UNITED STATES PATENT AND TRADEMARK OFFICE

APPLICATION NO.	FILING DATE	FIRST NAMED INVENTOR	ATTORNEY DOCKET NO.	CONFIRMATION NO.
10/717,906	11/21/2003	Hye Yong Park	9988.082.00-US	7371
30827	7590	05/11/2006		
MCKENNA LONG & ALDRIDGE LLP 1900 K STREET, NW WASHINGTON, DC 20006				
			EXAMINER HAWK, NOAH CHANDLER	
			ART UNIT 3636	PAPER NUMBER

Office Action Summary	Application No. 10/717,906	Applicant(s) PARK ET AL.	
	Examiner Noah C. Hawk	Art Unit 3636

DETAILED ACTION

Lickiss et al., Figure 4

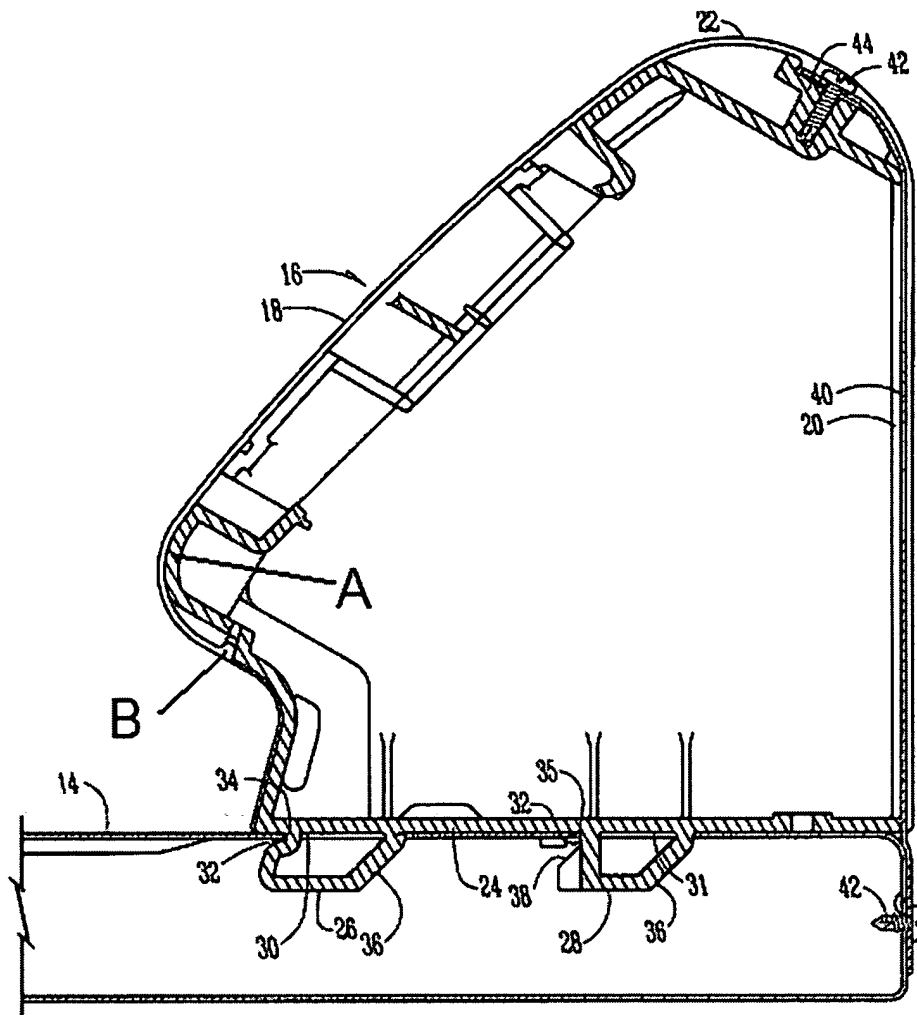
a. Regarding Claim 1; Marchand teaches a control panel assembly comprising a control panel (comprising parts 41, 54, and 60) and a display panel (53) with a fused planar contact between the display and control panels (See Marchand, Column 3, lines 65-68: "secured to a rear surface" is considered a fused connection between the display and the control panels.) Marchand fails to teach a curved contour to the panels. Lickiss teaches a control panel assembly having a curved control panel (A) and a display panel (18) that has a portion that follows the control panel. It would have been obvious to one of ordinary skill in the art at the time of invention to modify the device of Marchand by using control and display panels having curved contours as taught by Lickiss et al. in order to satisfy the design requirements of the specific artisan.

Marchand, Figure 3

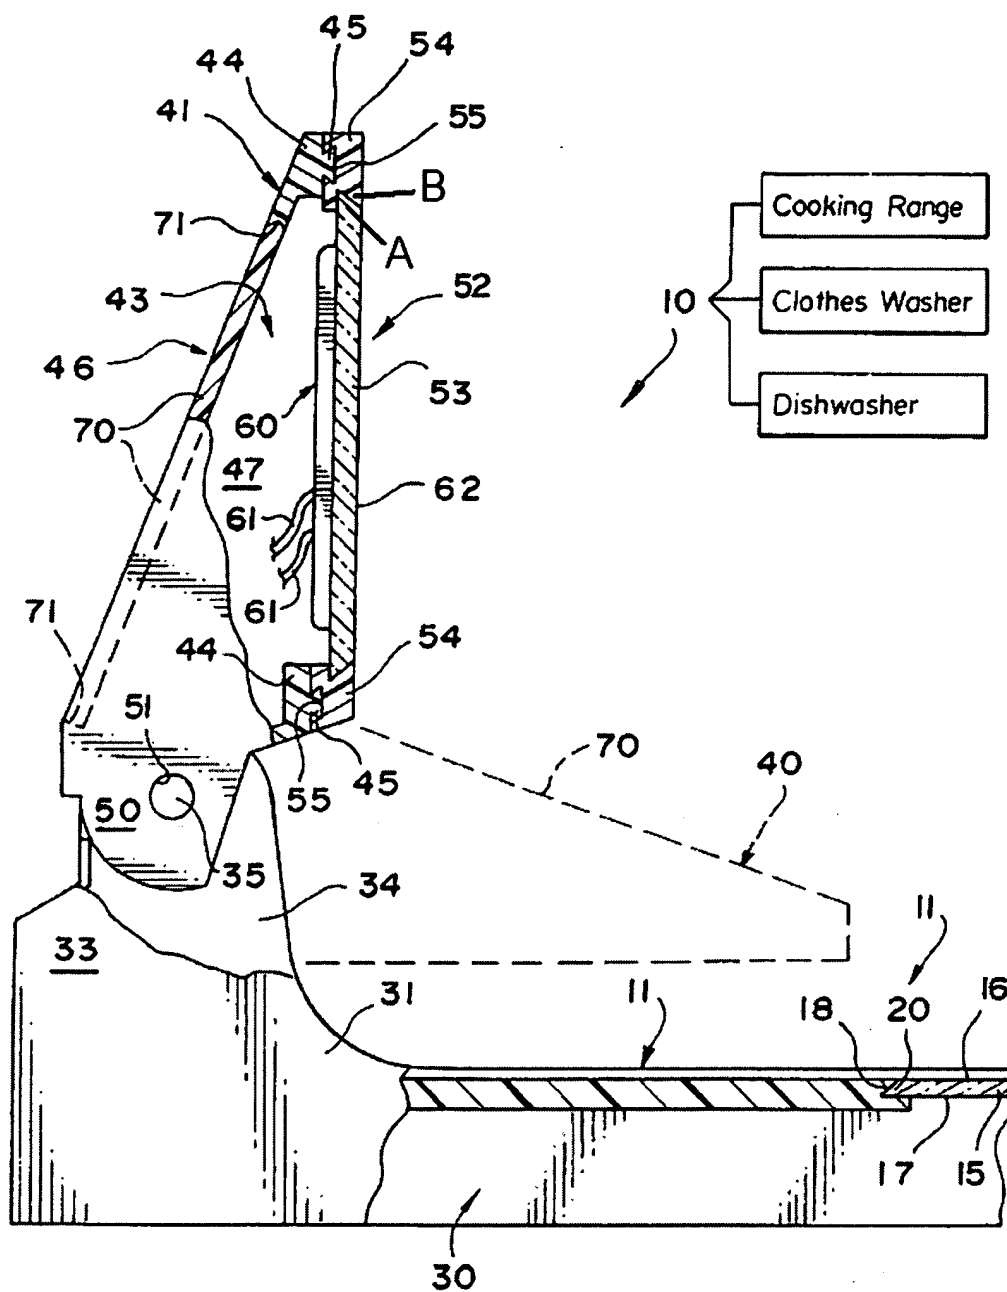
b. Regarding Claims 2 and 3, Marchand, as modified, further teaches that the display panel is provided with a first interlocking part (A) including a protrusion, and that the control panel has a second interlocking part (B) that receives the first part and includes a recess.

c. Regarding Claim 4, Marchand, as modified fails to teach a triangular cross section for the interlocking elements. It would be an obvious design choice to one

of ordinary skill in the art at the time of invention to use a triangular cross section for the protrusion (A) of the display panel and the recess (B) of the control panel in order to provide an angled rear surface on the display panel, allowing the display panel to be pressed into place from the front of the control panel.
